WILLIAMSON COUNTY, TEXAS

CHANGE ORDER NUMBER: 3

Roadway: CR 110 South

Change Order No. 3

Texas Department of Transportation		Design Division Standard	
LOW PROFILE CONCRETE BARRIER PRECAST BARRIER (TYPE 1) LPCB-13			
FILE: lpcb13.dgn	DWG: TxDOT	CHK: AM	DWG: VP
© TxDOT December 2010	CONT	SECT	JOB
REVISIONS	DIST	COUNTY	SHEET NO.
			86-A

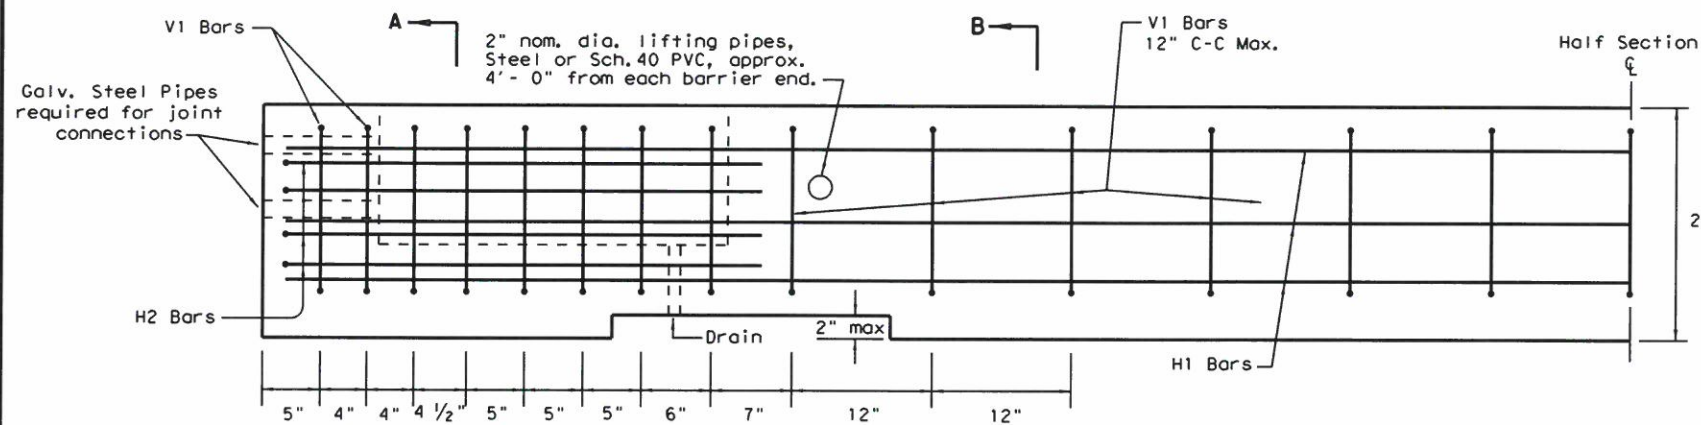
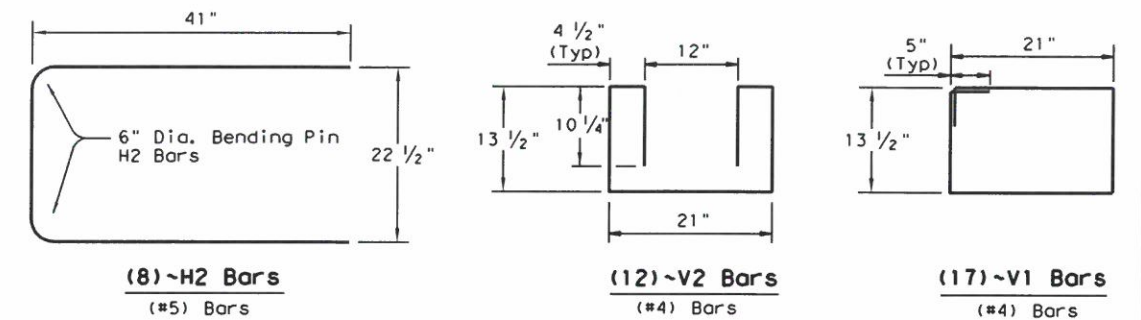
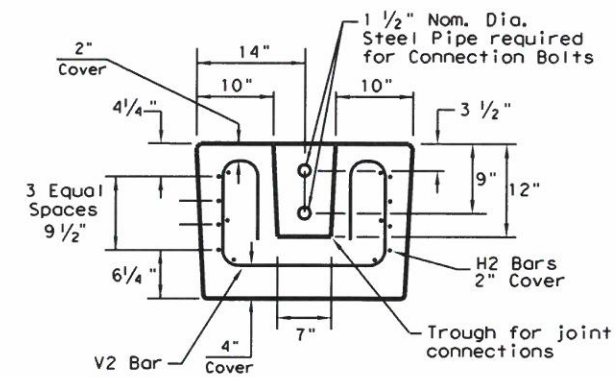
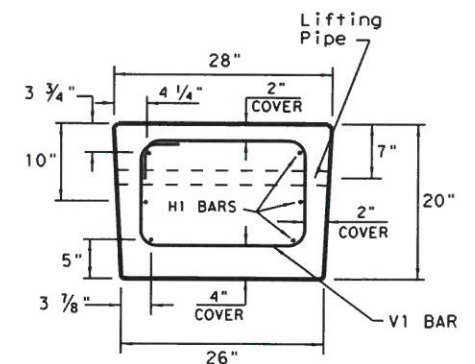
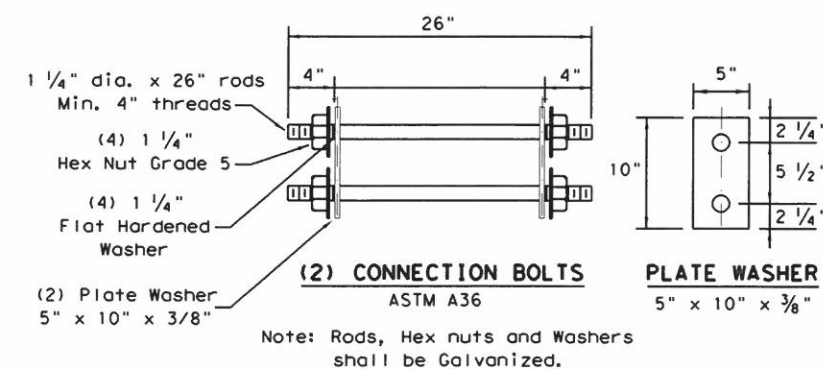
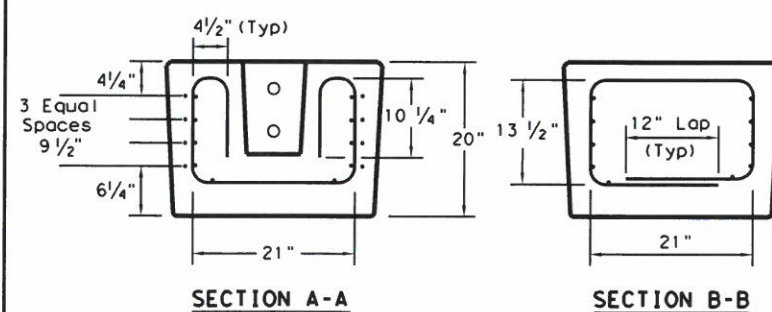
This Change Order also substitutes the Portable Single Slope Concrete Traffic Barrier (SSCB) with Low Profile Concrete Traffic Barrier (LPCB). The posted speed limit is 45 mph, which is the maximum speed limit allowed for use of LPCB. This will provide cost savings to the project and expedite construction.

Plan sheets 80A and 80B are added.
